Response to Submissions

Discovery Point Concept Plan – Modification 5

Table 1 *Matters Raised by the Department Planning and Environment and Agency Submissions*

Figure 1 Icon – Approved building envelope (left); Existing building outlined in red (right)

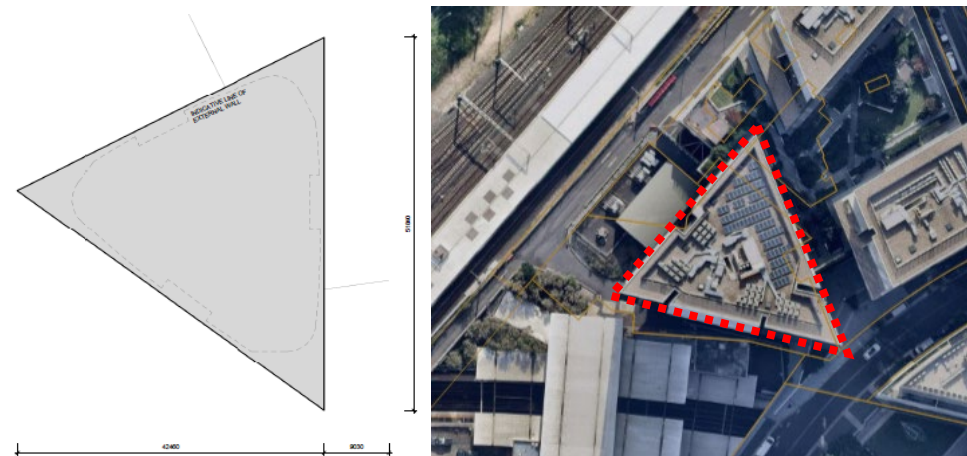
The Urban Design Report prepared by Group GSA (2023) outlines an indicative design for Building 14 of two distinct towers reaching a height of 5 storeys with an open centralised space. Amended concept plans in 'Envelope Parameters Plan DA3-016 C' propose to remove the indicative line of the external walls for the two towers for Building 14. Further information is required to demonstrate that the proposed	Throughout the assessment of subsequent detailed design stages in Discovery Point, the individual detailed building designs have been assessed based on the approved building envelope, rather than the 'indicative line of external wall'. As an example, Icon (approved under DA-2016/99) adopts a triangular building form which correlates to the approved building envelope, rather than correlating to the splayed corners implied by the indicative line of external wall illustrated in Figure 1 .

amendment to 'Envelope Parameters Plan DA3-016C' is considered of minimal environmental impact. The justification is to outline whether an environmental assessment has been undertaken based on the indicative lines as part of the original Concept Plan approval (as amended); whether any further environmental assessment is required as a result of the removal of the indicative line of the external walls; and if an alternate indicative line of external walls or building articulation zone may be appropriate given the recent design competition for Building 14.

No change is proposed to the approved envelope for Building 14. As such, there are no greater environmental impacts resulting from the modification application than what has already been tested and deemed acceptable for the site. The substance of the modifications is of minimal environmental impact and the proposal satisfies clause 5(b) of the Savings and Transitional Provisions.

Given the recent design competition, the Proponent has been working through the detailed design with Rothelowman. Rothelowman are continuously exploring opportunities to minimise environmental impacts of the future building of Building 14. The Reference Design illustrates that a building can be delivered well within the maximum approved envelope, enabling significant flexibility and an articulated building form.

This modification application has undertaken a degree of environmental assessment of the Reference Design, particularly in relation to amenity, and overshadowing to private and public spaces. It is acknowledged that a detailed environmental assessment will be undertaken as a part of the future SSDA submission.
